## Models Affected/ Items of Concern

Prior to releasing 2005 ZR 900 or Firecat 500/700 models, please service the following items. See Service Bulletin 2005-1-06 for VIN Range and related information.

### 2005 ZR 900 and Firecat 500/700 Models

Fig. 1

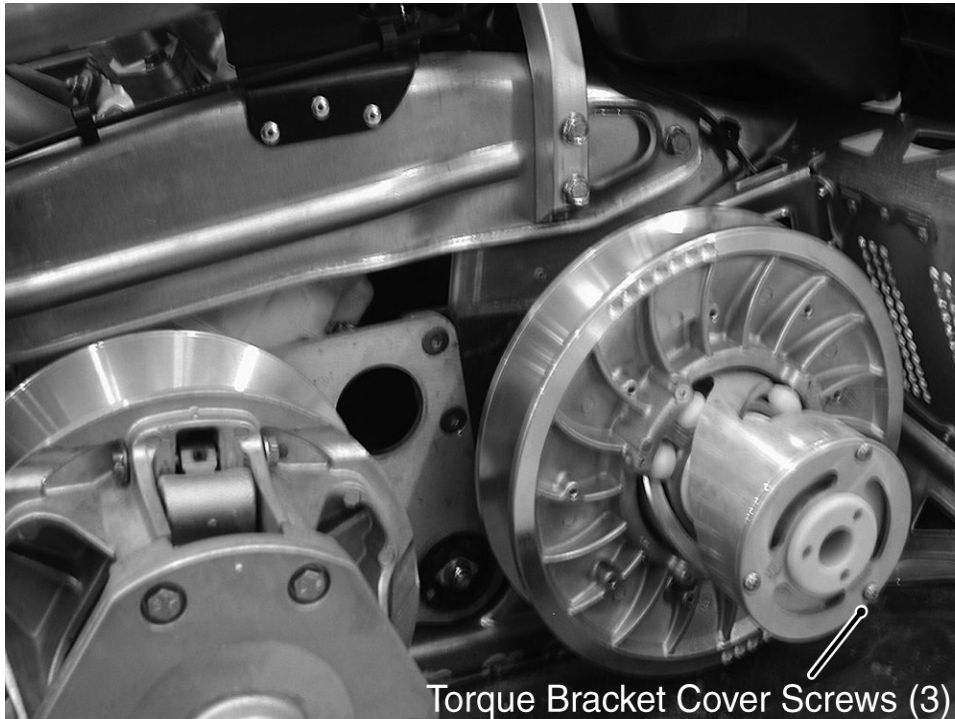
The three torx-head screws securing the torque bracket cover may not have been properly tightened and may come loose. Remove each screw (one at a time); then add **blue Loctite #243**, install the screw, and tighten to 33-37 in.-lb. Repeat for remaining screws. See Fig. 1.
